**TO:** Kristopher Apanian, TAIT & Associates, Inc.  
**FROM:** Amber Wood Hicken, Planner I  
**DATE:** 7/25/25  
**SUBJECT:** Parker Pointe, Auto Parts Store, Site Plan  
Review Comments 03

*Staff Comments 03*  
*SP25-025; Auto Parts Store*  
*Site Plan*  
*7/25/25*

PROJECT:  
NEW O'REILLY AUTO PARTS STORE  
STROH RD  
PARKER, CO #2

SITE PLAN COVER SHEET

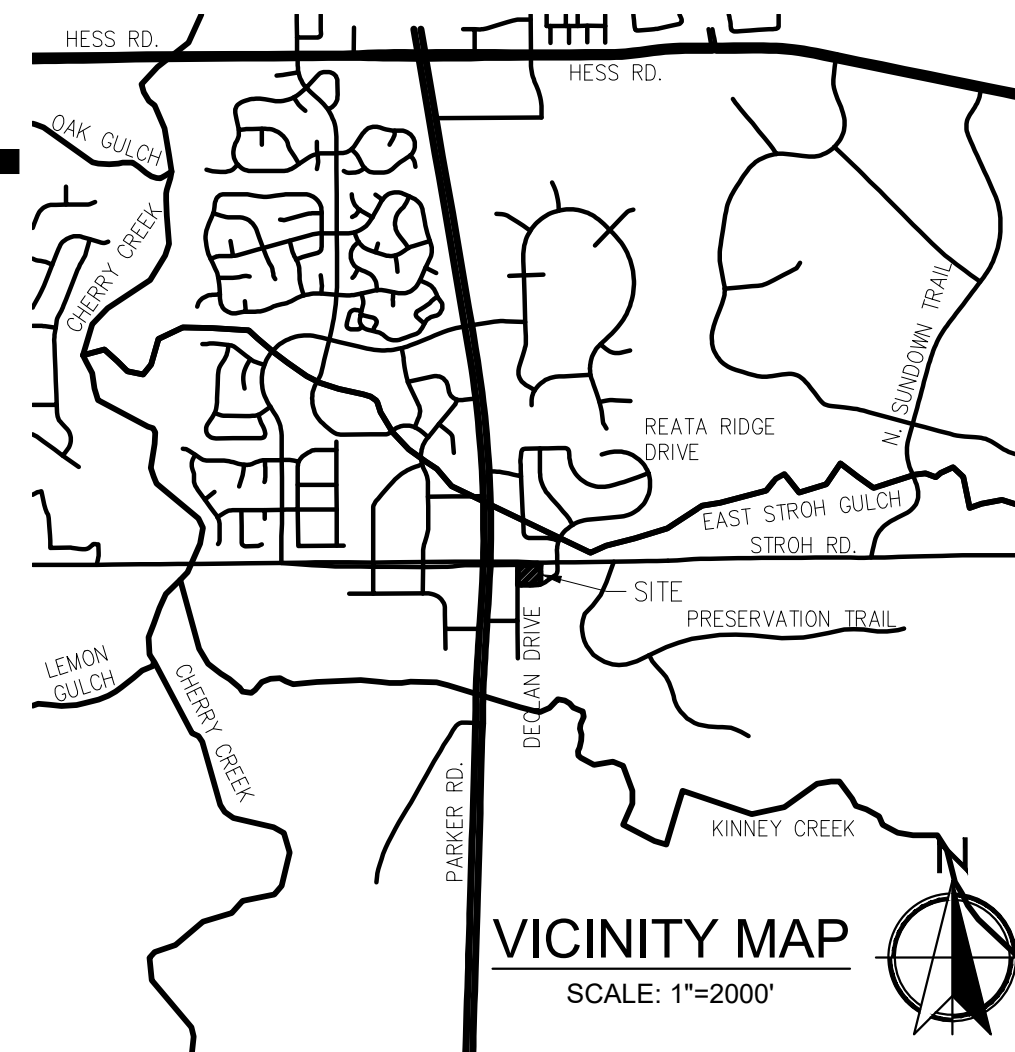
add zoning (Mixed-use Community)

**1 LANDSCAPE PLAN**  
L1.0 SCALE: 1" = 20'-0"

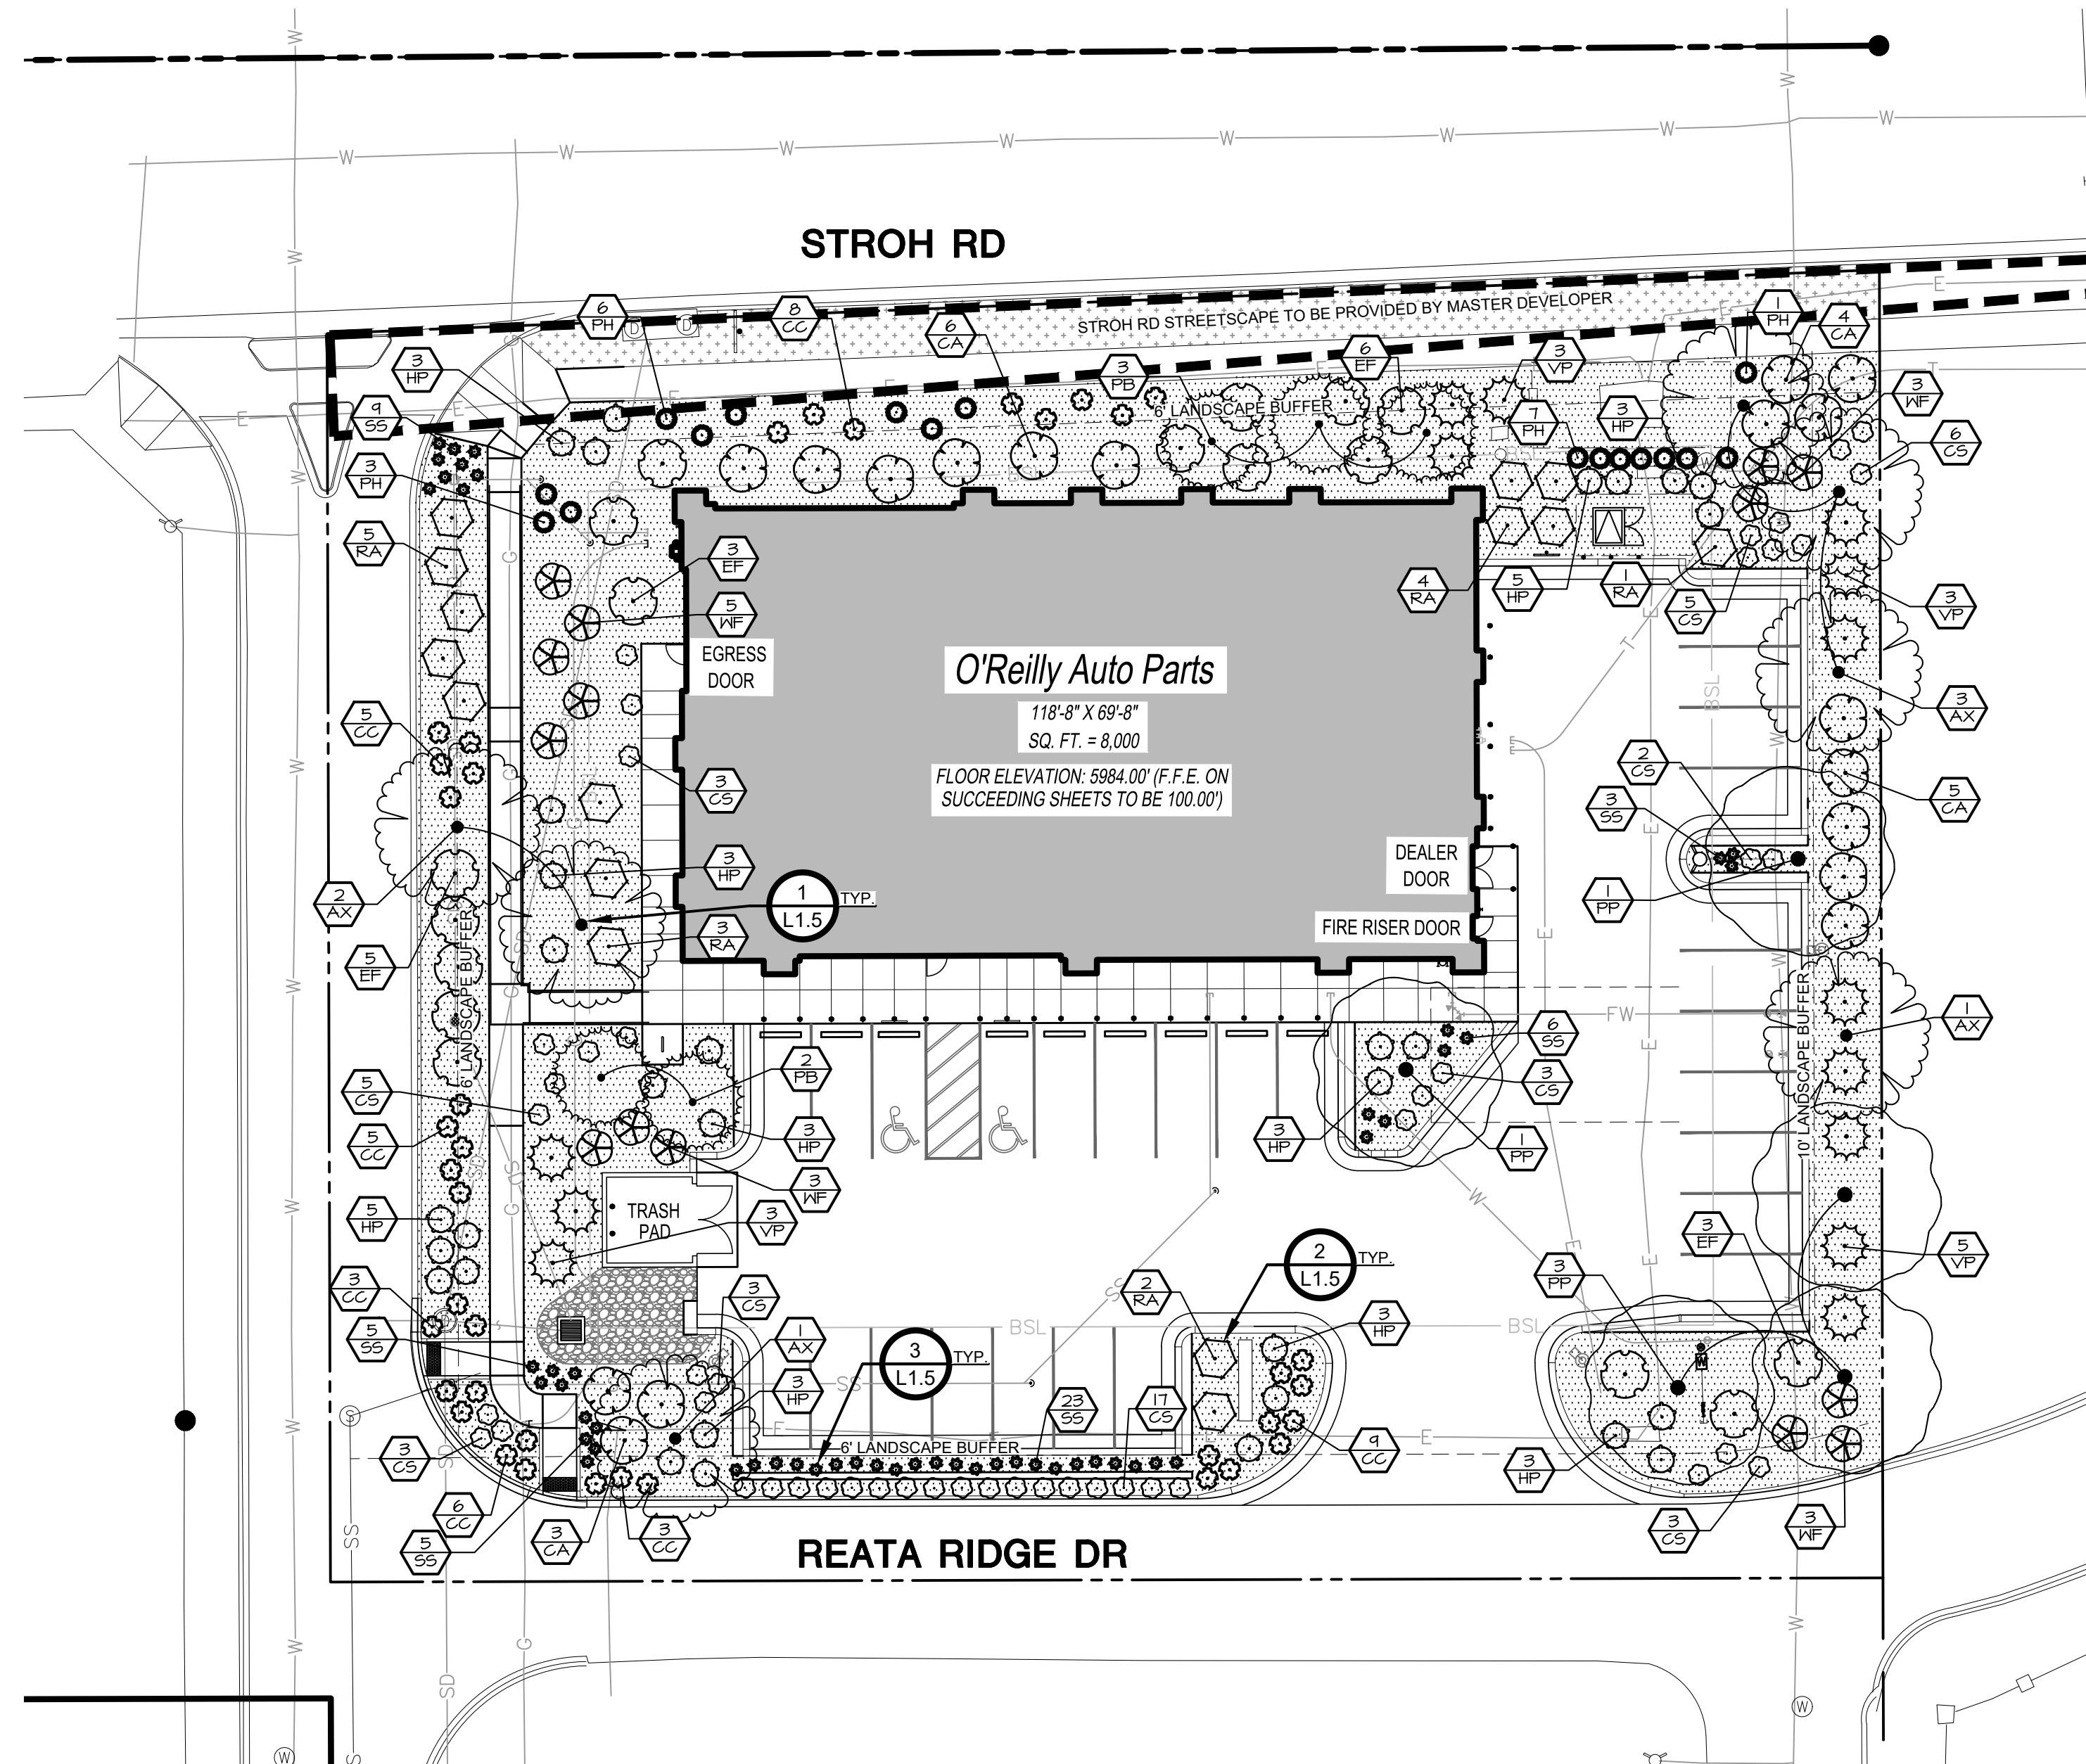
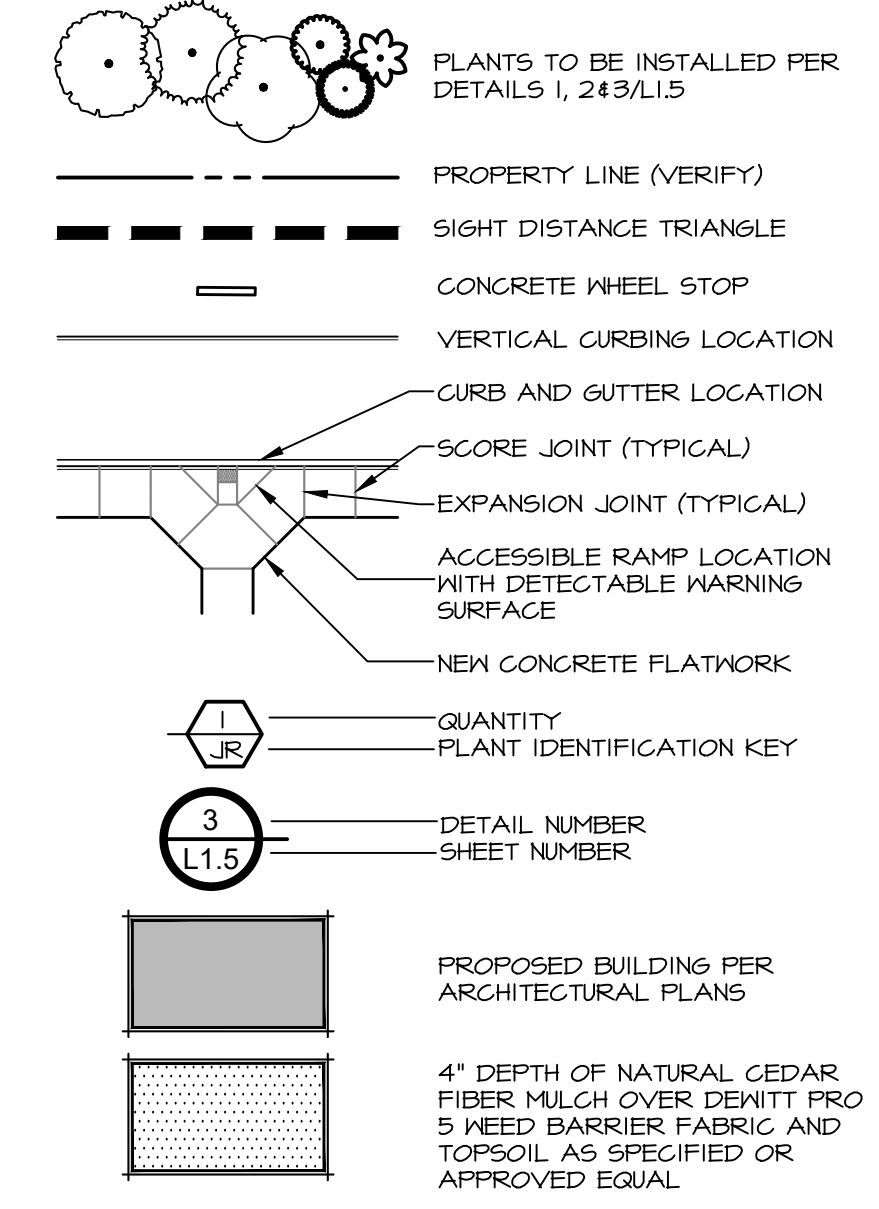
deciduous trees must be 2.5" caliper.  
ornamental trees must be 2" caliper.  
please note what type of trees are proposed and adjust caliper if necessary.

shrubs must be in 5-gal containers

PROJECT:  
**NEW O'REILLY AUTO PARTS STORE**  
STROH RD  
PARKER, CO #2  
**SITE LIGHTING PHOTOMETRICS**

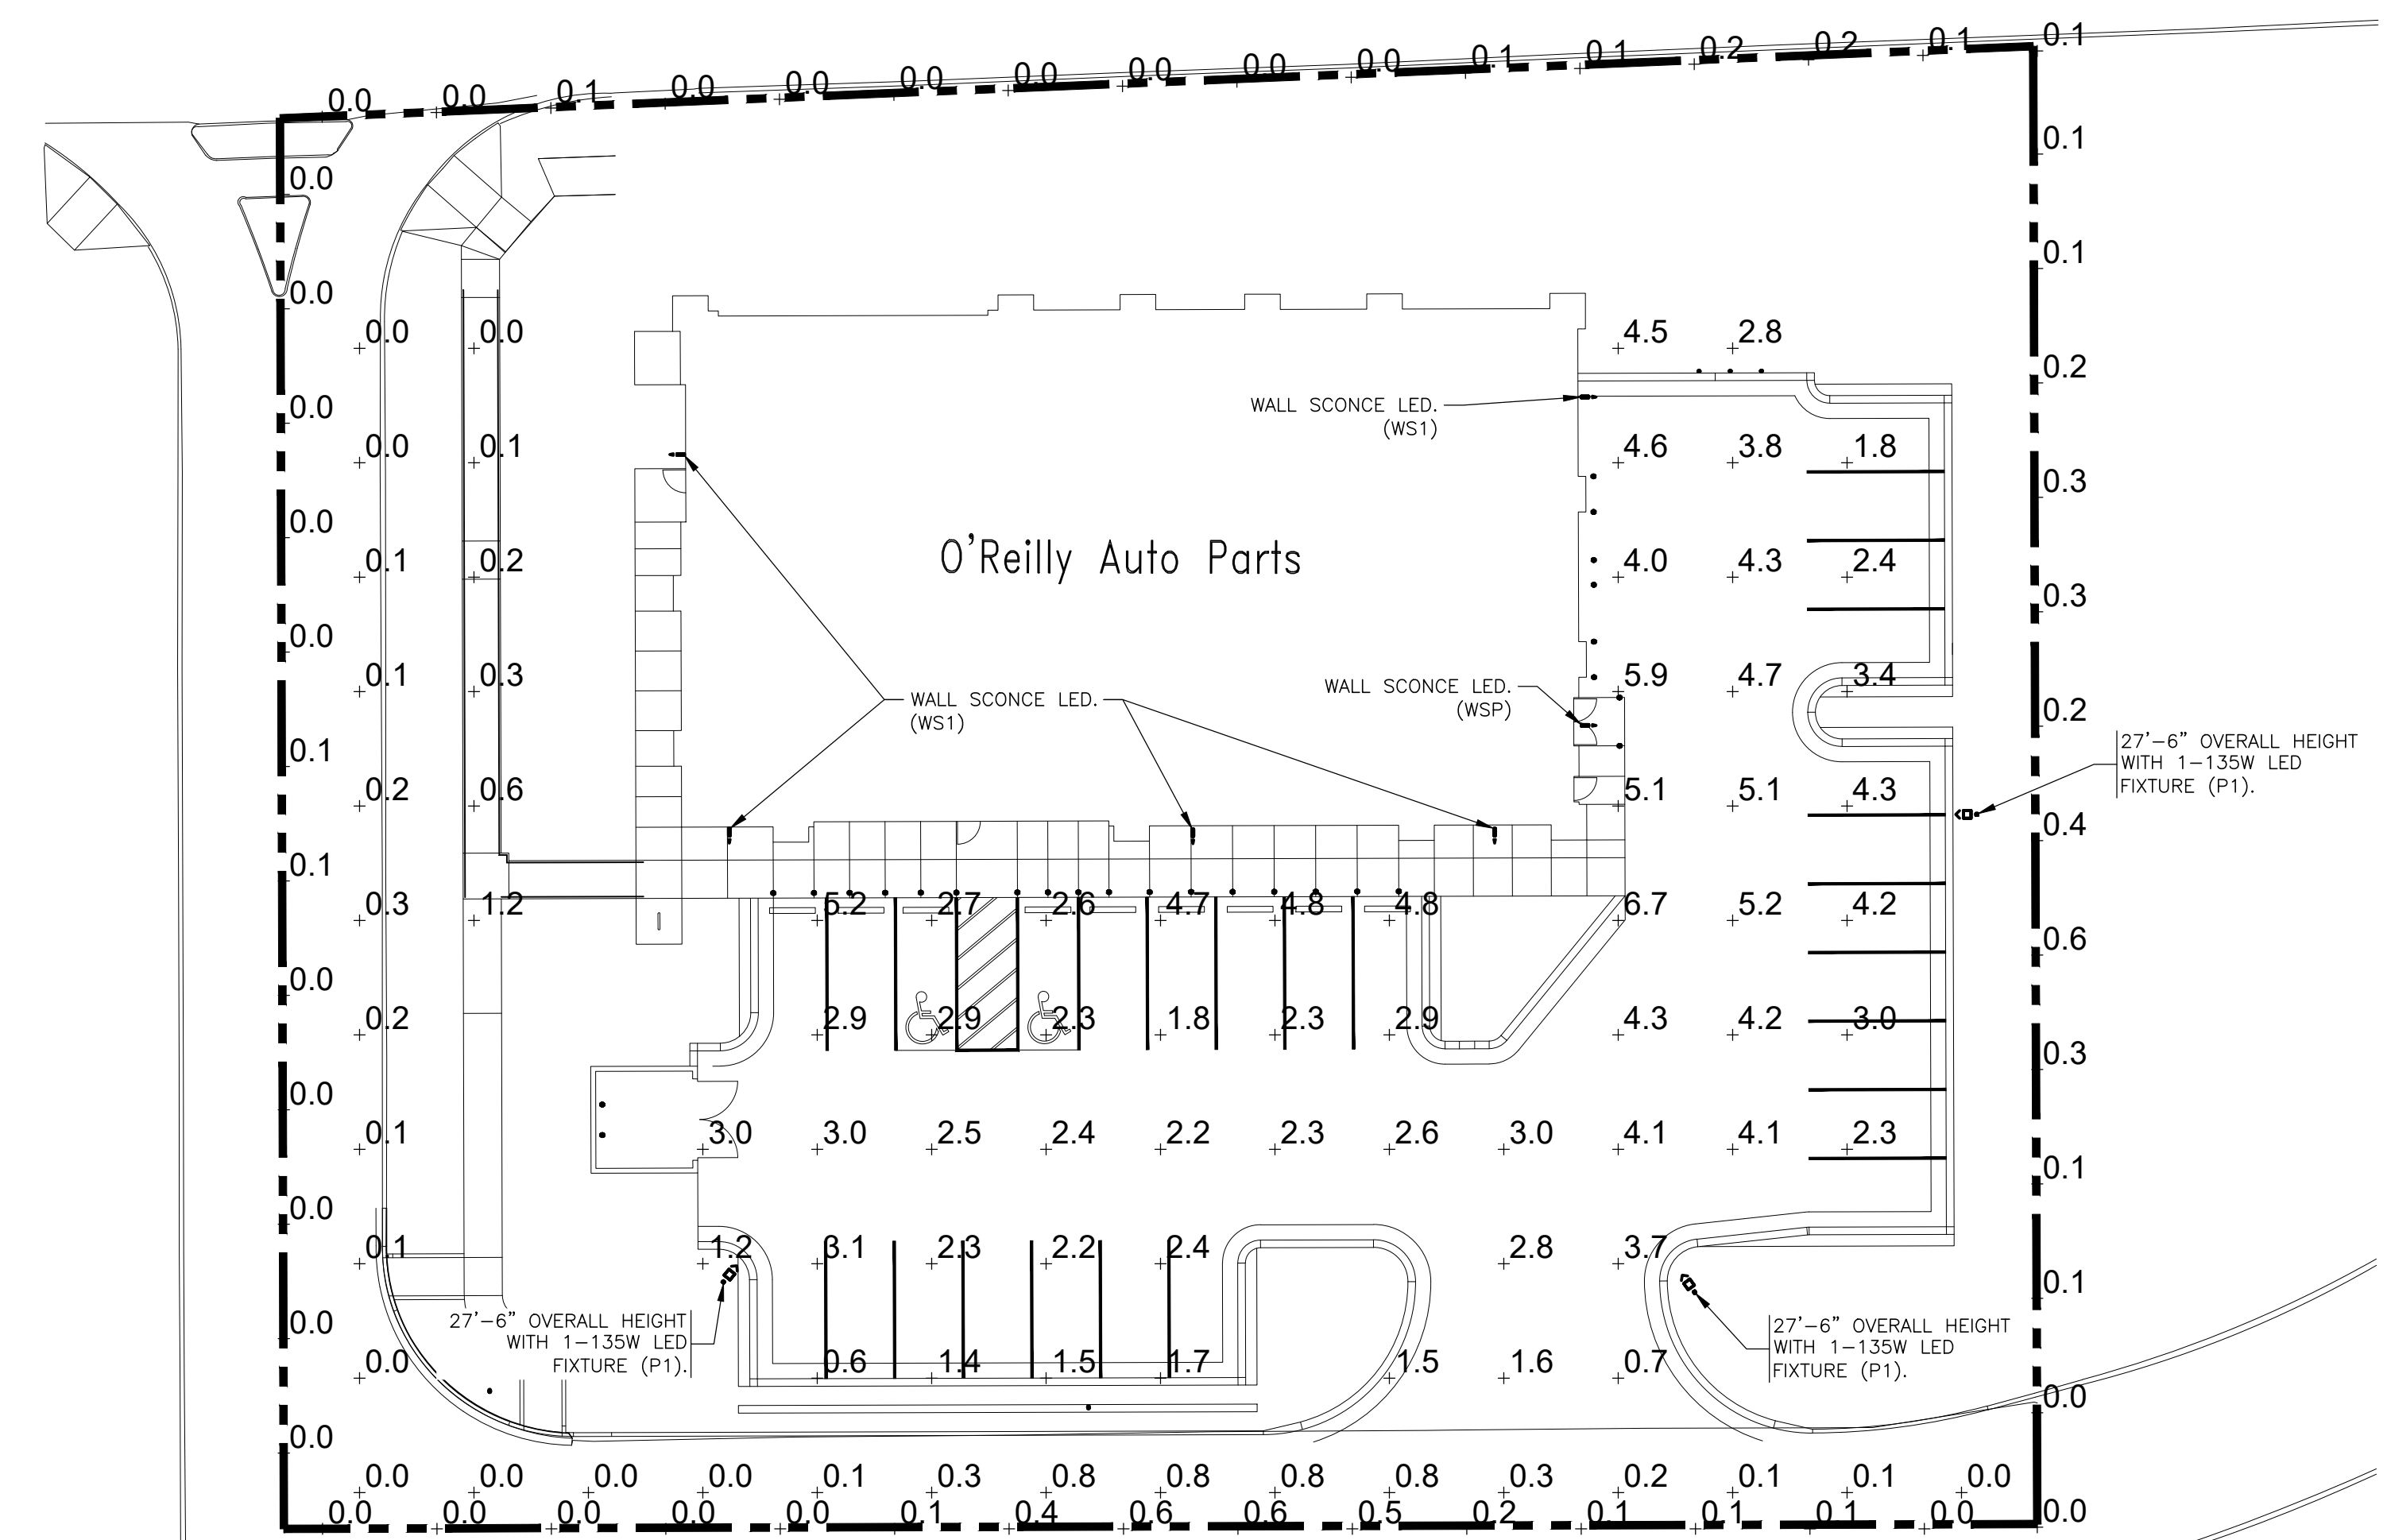
include quantities of each

include table for uniformity ratio for drive aisles and parking lot ( should be 6:1 max to min)
